MINUTES: Regular Session – September 8, 2016

CONTINUATION OF THE SITE PLAN REVIEW APPLICATION OF LECIL G.
TOWNSEND/DOLLAR GENERAL (CASE #102-2016 SP) IN FRANKLIN TOWNSHIP

The following are Gresham, Smith and Partners' responses to your comments from a letter from Robert Ware to you dated August 1, 2016, regarding the project named above.

SITE LAYOUT & UTILITY PLAN

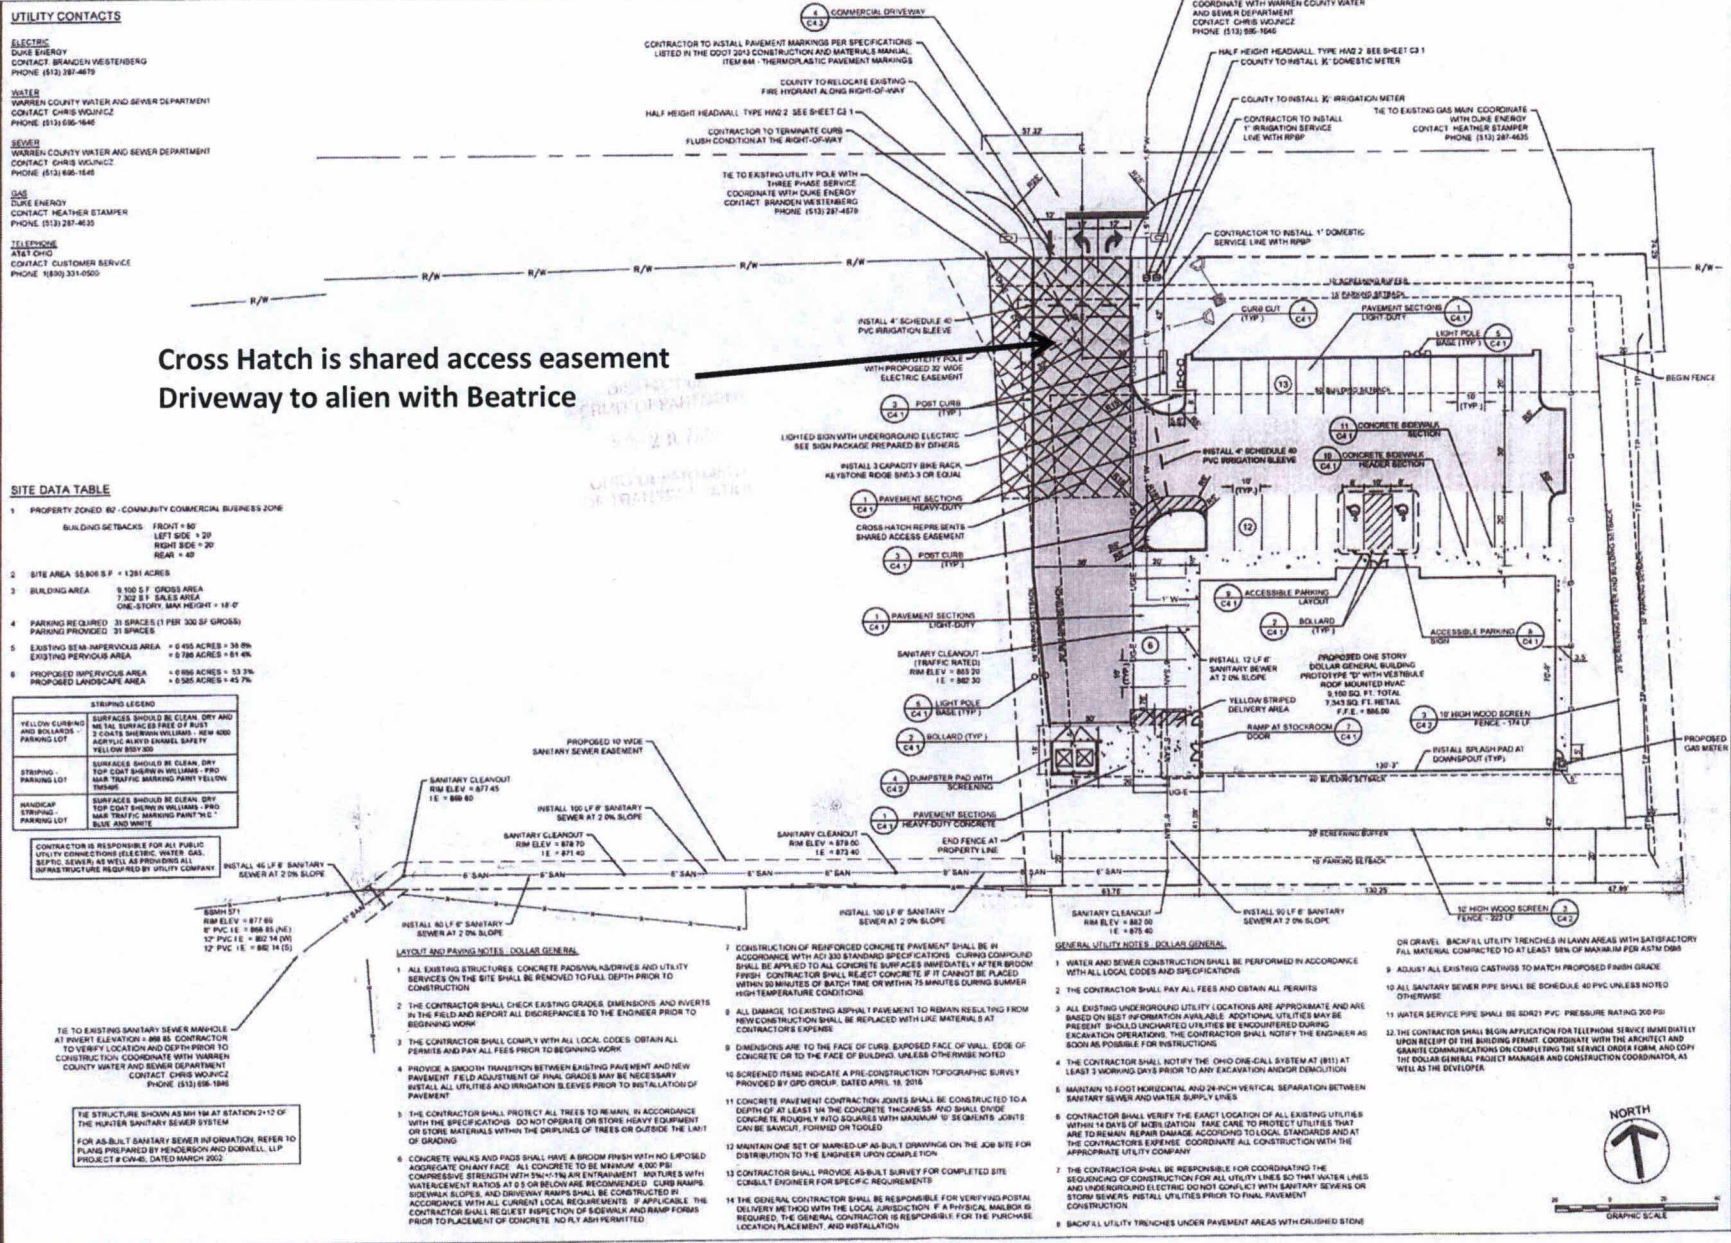
5. Comment: The S.R. 122 driveway intersection design, location, and construction shall be to the permitting satisfaction of ODOT.

6. Comment: The shared driveway access easement for the abutting property to the west shall be provided as shown on the plan;

8. Comment: A walkway shall be installed along the site frontage as required per Article 3 Section 3.303(B).

Response: ODOT approved permit is attached.

Response: The shared driveway easement will remain and be dedicated when the subdivision plat is recorded.

Response: A 5' sidewalk has been added to the plans.

EXTERIOR ELEVATIONS & FINISH SCHEDULE

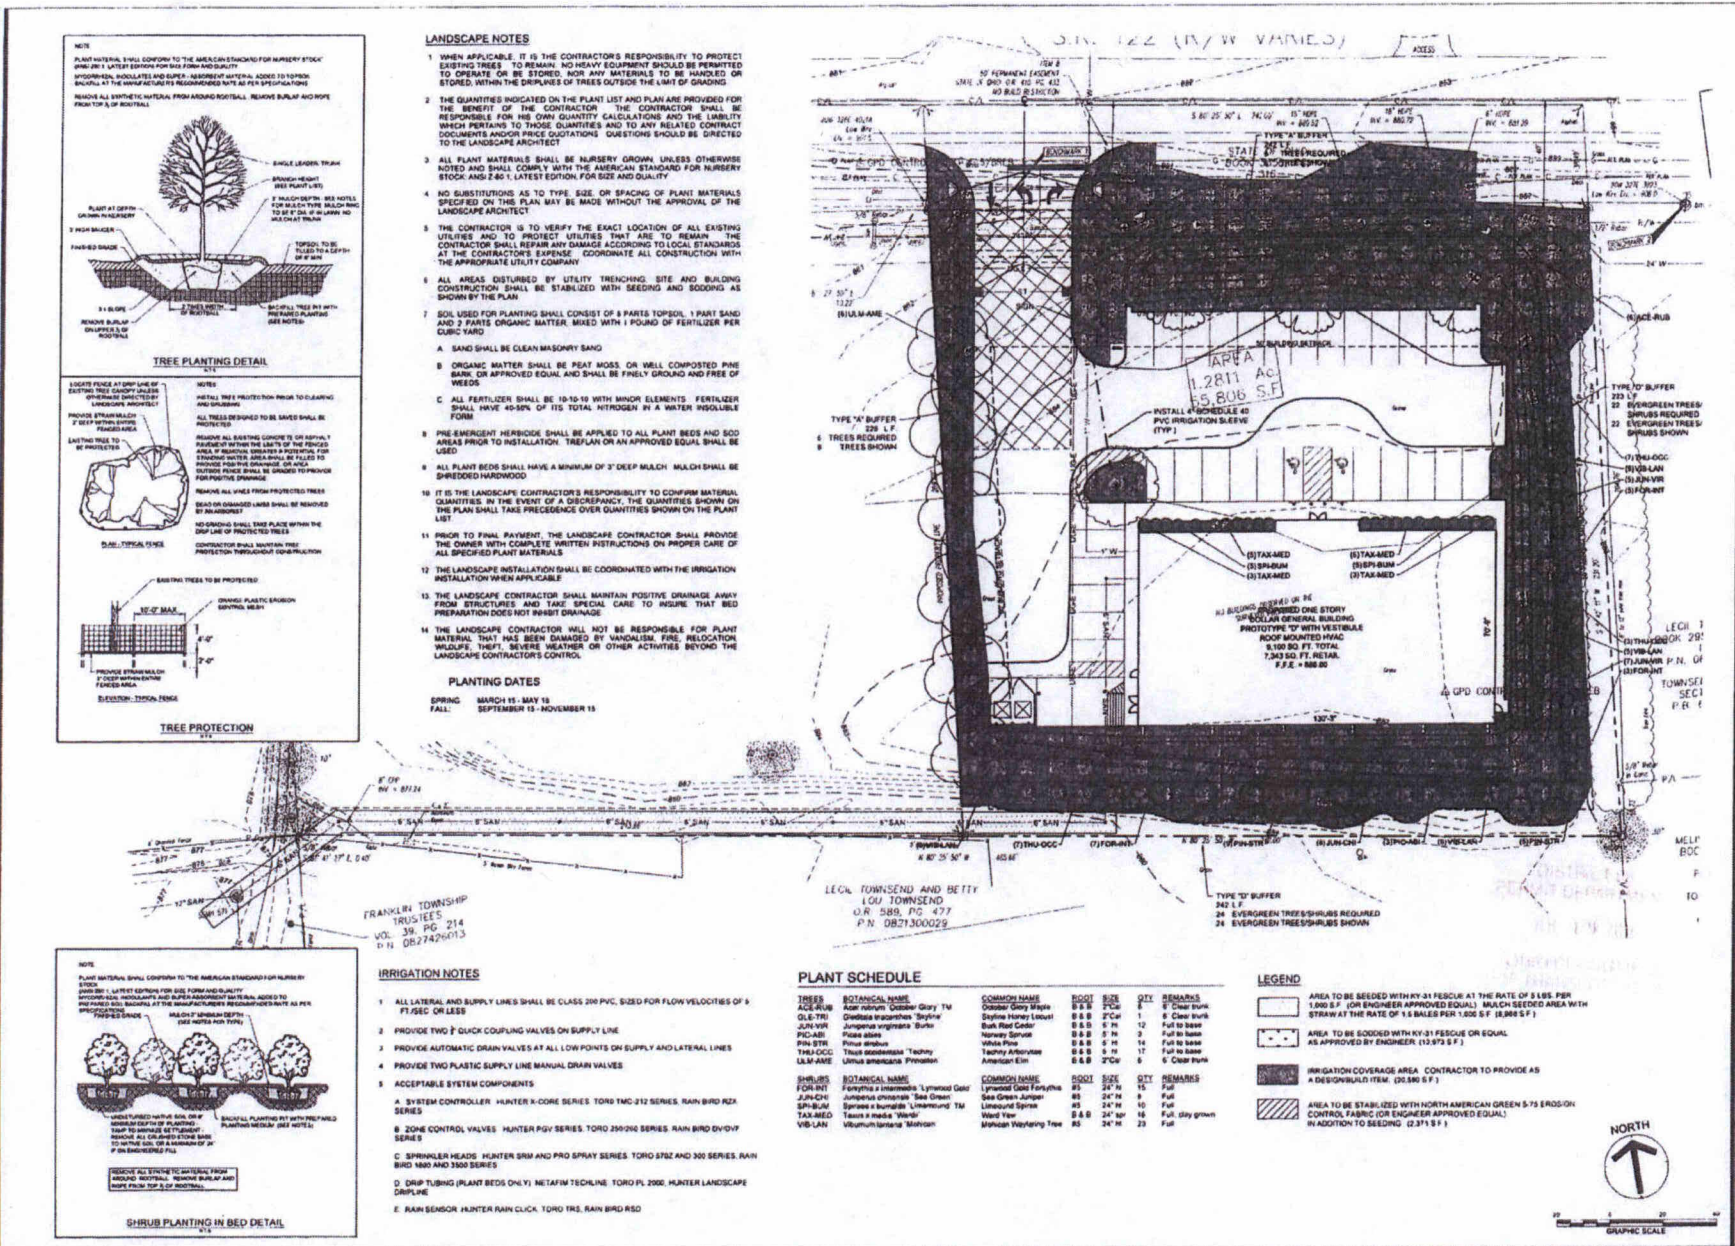
- (1) Replace the proposed building design with one that is harmonious in character with the surrounding area with regard to scale, mass, and orientation: full brick on three sides with a raised stucco top that includes a change in elevation on each end, as referenced in the picture attached hereto and made a part hereof.;
- (2) Signage shall comply with Warren County Rural Zoning Code Article 3, Chapter 6;

1. Comment: Replace the proposed building design with one that is harmonious in character with the surrounding area with regard to scale, mass, and orientation;

Response: The building will have masonry on three (3) sides with metal panels on the rear. The rear yard is screened with a 10' high fence and plant material. Revised building elevations are attached.
2. Comment: Revise the signage to be compliant with Zoning Code Article 3, Chapter 6;

5'-0 1/2" x 10'-0 1/2" PYLON

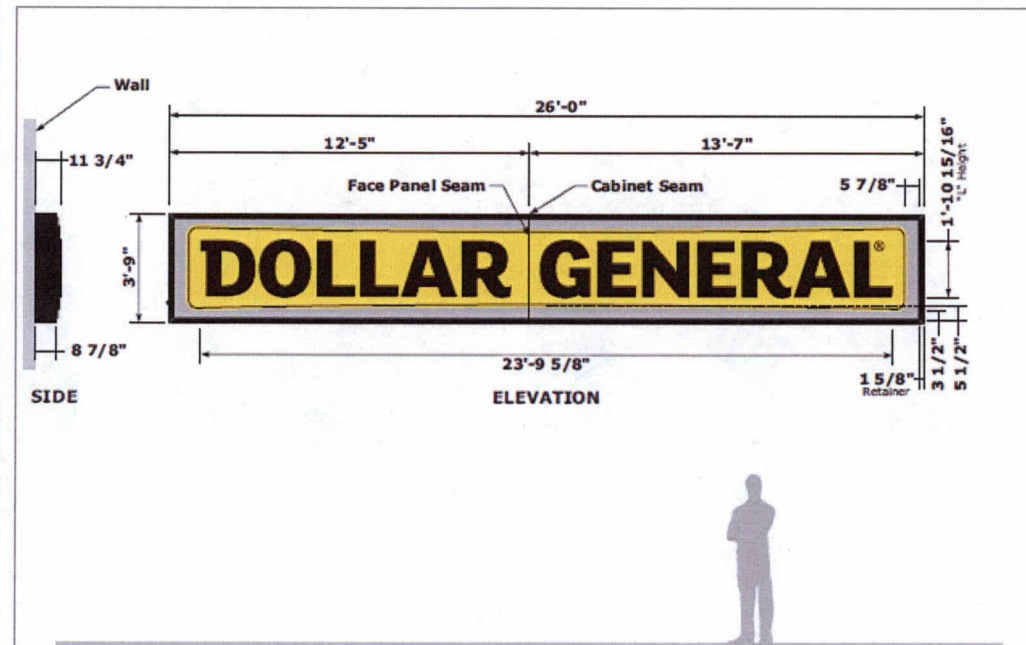
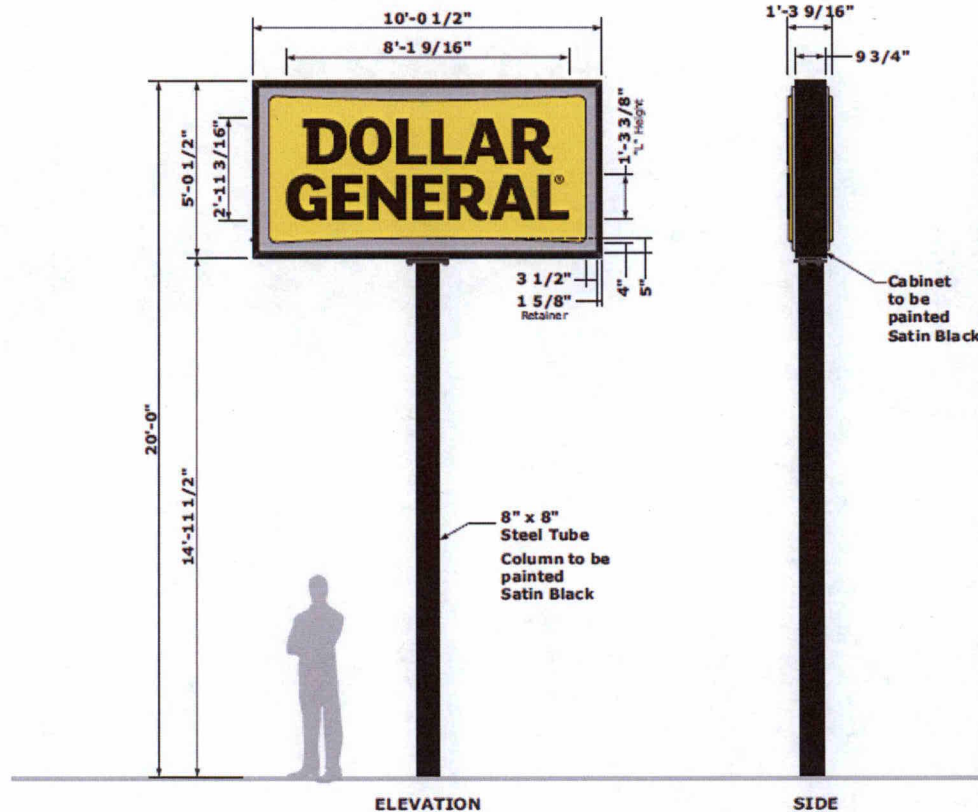
Response: Signage has been revised to meet the ordinance, detail attached.
3. Comment: All exterior lighting inclusive of sign illumination shall meet the requirements of Zoning Code Article 3, Chapter 5;

Response: Lighting Plan attached.
4. Comment: The existing line of trees inside the eastern boundary shall remain as part of the required buffer screen;
